SHOP DRAWING / SUBMITTAL REVIEW

ROOF TRUSS PLACEMENT LAYOUT

BUILDER: MKM LEGACY

EAST TOWN CROSSING BLDG B MAIN ROOF

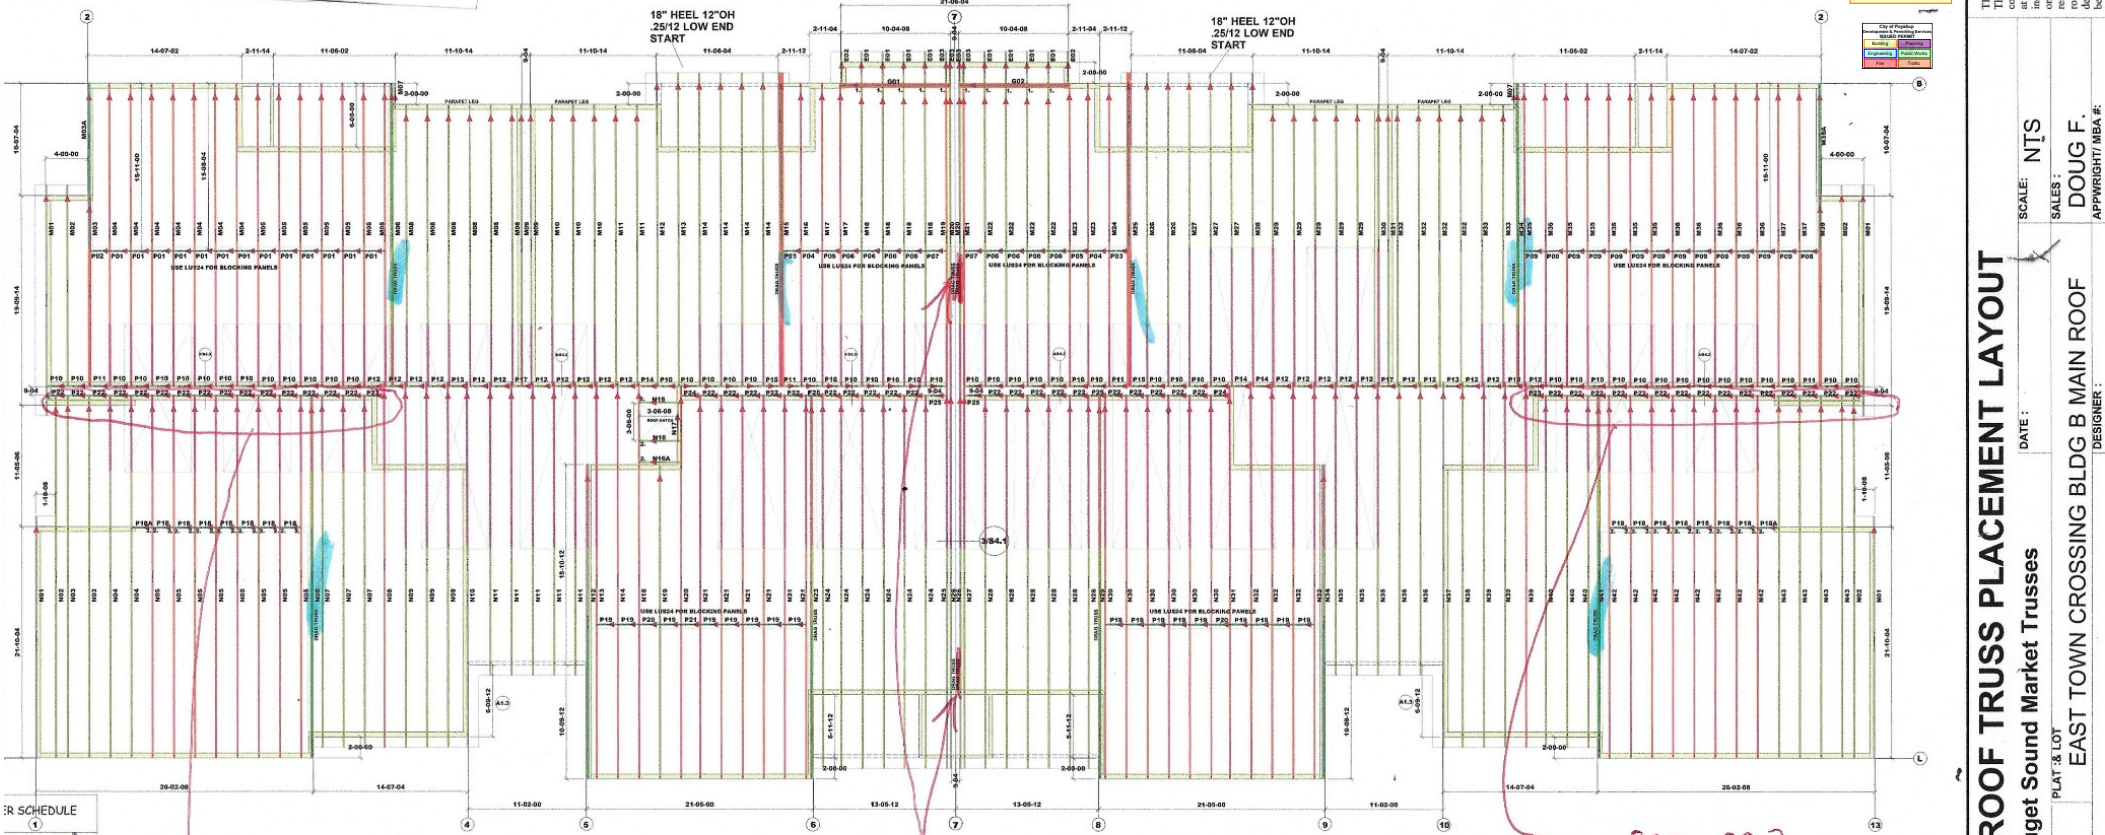
P22 & P23
 DO NOT NEED TO
 BE DESIGNED FOR
 DRAG

DRAG TRUSS
 ONLY REQUIRED
 OVER LEFT WALL
 (SHEAR WALL)

P22 & P23
 DO NOT NEED TO
 BE DESIGNED
 FOR DRAG
